SERVICE BULLETIN MAINTENANCE OF WAY EQUIPMENT

DATE: 4-17-2002 **BULLETIN NO:** 02-013

TITLE: TAMPING TOOL BRACKET CAP SCREW AND LOCK NUT SERVICE GROUP

PRODUCT SERIES / MODEL: 6700S and 3300 Tampers

FIGURE 1
6700S WORKHEAD

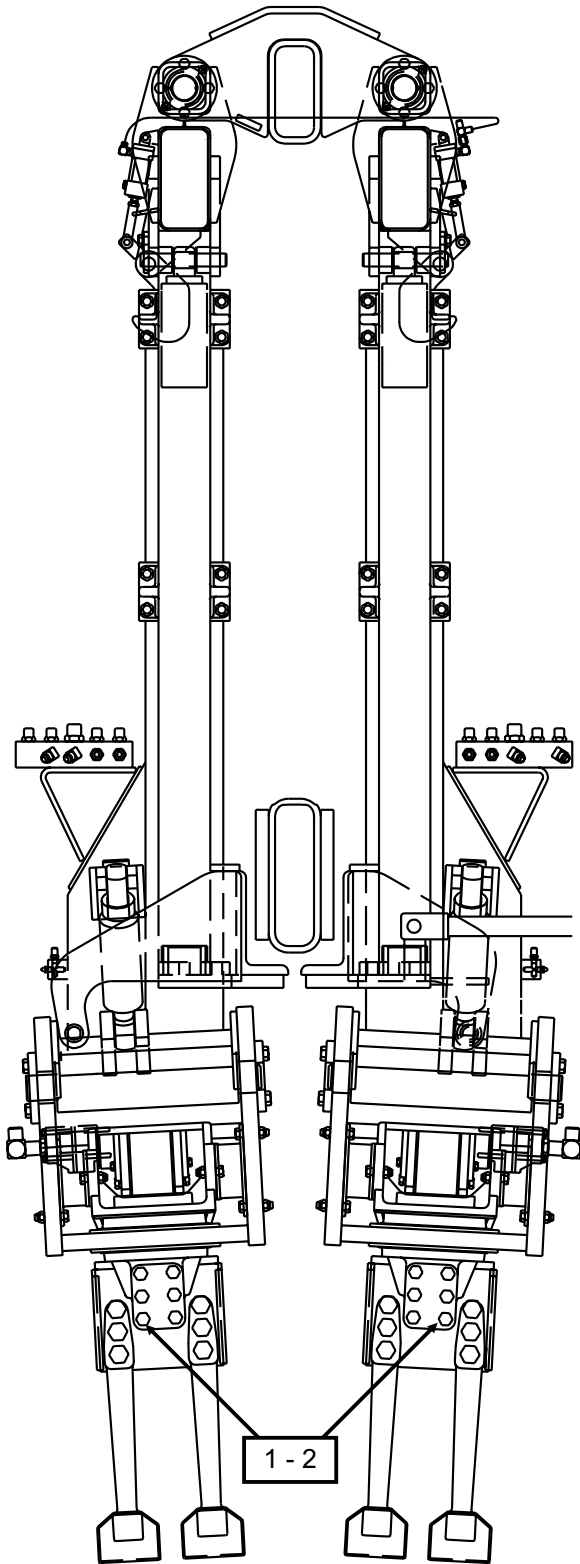
SUMMARY: There are occasions when it is very difficult to tighten the cap screws that attach the tamping tool bracket (snubber bracket) to the motor base because it can be difficult to get a wrench on the lock nut. This difficulty is due to variations in the motor base casting that does not allow sufficient wrench clearance. To remedy this situation, all future production machines from the Ludington, MI. facility will have a high lock nut which is twice as long as the current lock nut. This will allow the hex on the nut to protrude past the webs on the motor base for easier access with a wrench. A longer screw is also required in conjunction with using this lock nut.

- Removing the existing tamping tool bracket cap screws and lock nuts, and replacing with new longer cap screws and high lock nuts.

1. With the workheads locked in the TRAVEL position, locate the existing six cap screws (1) and lock nuts (2) that secures each tamping tool bracket to the motor base.
2. Remove one existing cap screw (1) and lock nut (2) at a time and replace with one new 3/4"-16 x 4" hex head cap screw (2) and 3/4"-16 high lock nut (1). Continue to replace each cap screw until all six cap screws and lock nuts are changed out in the tamping tool bracket. Then torque all six cap screws to 300 ft-lbs.
3. Repeat Step 2 to replace the six cap screws and lock nuts in all eight tamping tool brackets on the machine.
